From: Luke Eldridge <luke.eldridge@devinehomes.co.uk>
Sent: 19 June 2026 16:44:23 UTC+01:00
To: "Joseph Swift" <joseph.swift@midsussex.gov.uk>; "Rosie Baker" <rosie.baker@devinehomes.co.uk>
Cc: "Billy Clements" <billy.clements@devinehomes.co.uk>
Subject: RE: DM/26/0073 - Update - Layout amends, trees/drainage, AH

I wanted to follow up on your email of 21/05/2026 (below) relating to the surface water drainage and the interaction with the Ancient Woodland. I wanted to provide some more details and explanation as to the proposed solution and methodology, how this avoids impacts on the Ancient Woodland and also specifically address the appeal decision you shared relating to land at Rowhook Road, Rowhook, Horsham.

Response to Specific Queries

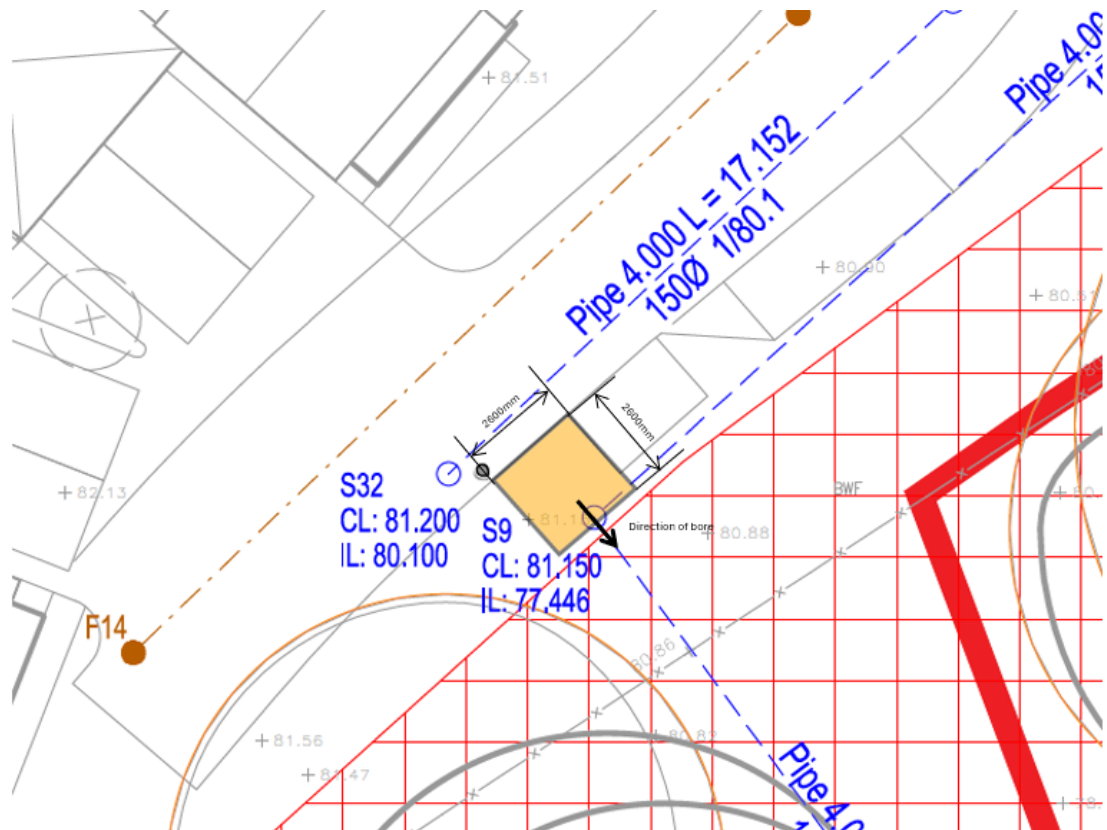
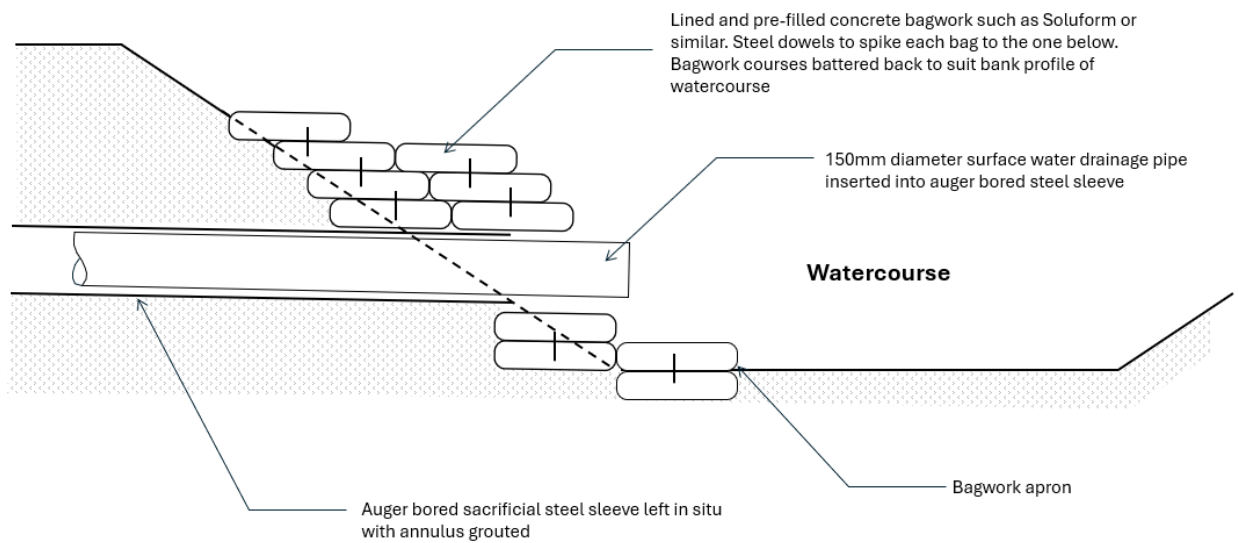
1. It appears that it would require a substantial launch and reception pit alongside the use of heavy hydraulic jacking equipment. I would be concerned that the launch pit could encroach into the 15m buffer of the Ancient Woodland and how the reception pit be formed as the outfall and headwall would be located within the Ancient Woodland.

Reception Pit: *A reception pit at the outfall/within the Ancient Woodland is not required in this case. The bore will be undertaken from a launch pit outside of the Ancient Woodland buffer (in the position of manhole S9 on the Drainage Layout) and will be bored in a single location to emerge out of the bank of the watercourse. A sacrificial steel sleeve will be inserted as part of the boring, meaning that only short 1m pilot rods would need to be removed at the outfall end. The final drainage pipework would then be installed through the steel sleeve which would be left in situ. The pilot rods can all be carried out by hand, resulting in no need for heavy machinery moving back and forth through the Ancient Woodland. The pedestrian route to recover the pilot rods can be fenced to minimise the area of human activity, and the ground appropriately protected.*

Launch Pit: *as above, the launch pit would be formed outside of the Ancient Woodland buffer, in the position of manhole S9 on the drainage layout. The boring rig can be operated from a small launch pit which would typically be either a 2.4m diameter pre-cast concrete ring manhole, or a square pit of 2.6m x 2.6m. The size/location of the launch pit is indicated on the plan below (orange square). This can be conditioned (as part of detailed Method Statement) to occur outside of the Ancient Woodland buffer, with appropriate ecological and arboricultural supervision and permanent protective fencing used to prevent access to the buffer zone. No heavy hydraulic jacking equipment is required to be used, positioned or operated within the Ancient Woodland buffer zone or Ancient Woodland itself.*

Headwall: *The headwall would be formed non-invasively as a concrete sandbag headwall. Concrete sandbags would be laid under and around the outfall pipe to prevent the risk of soil erosion to the bank of the watercourse. Below is a generic cross section demonstrating the type of headwall construction. A suitable type of pre-filled lined bagwork would be used, such as Soluform, to ensure containment of any cement fines, ensuring there would be no ecological risk or adverse impact whilst the bags harden. This form of bagwork can be hand placed, so that there is no need for heavy machinery to operate within the Ancient Woodland or its buffer zone to form the headwall.*

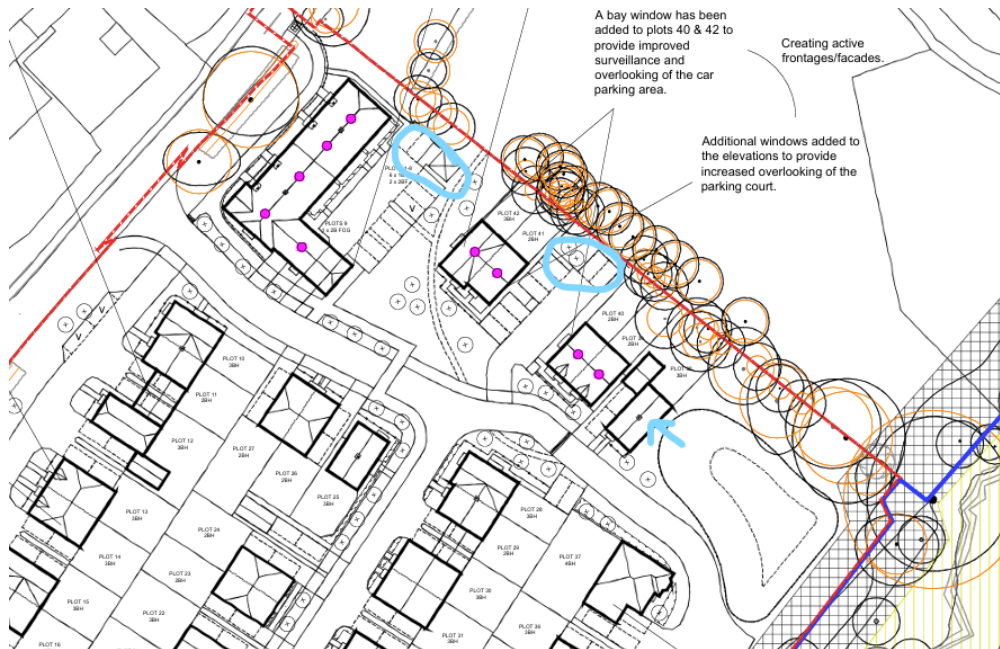
- Regarding the overlooking of the recreational ground, I accept the explanation to some degree. However, I would like to see amendments to Plot 39, with the front doors relocated to the south-east elevation. This would improve the immediate setting and provide better surveillance of the pond and main play area by creating a more active frontage.
- Furthermore, I would encourage the inclusion of additional FOGs in the marked locations, as these would also improve surveillance and help with housing delivery by adding two further units to the scheme.

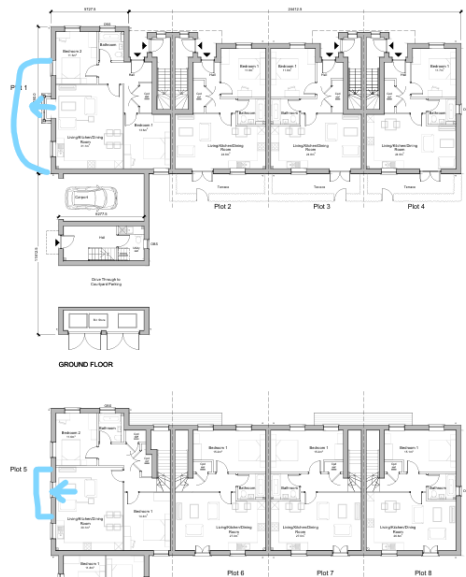
- Regarding the flats without direct access to private outdoor space, I do not accept the explanation provided. Please adjust the levels and create directly accessible outdoor spaces for the marked units.
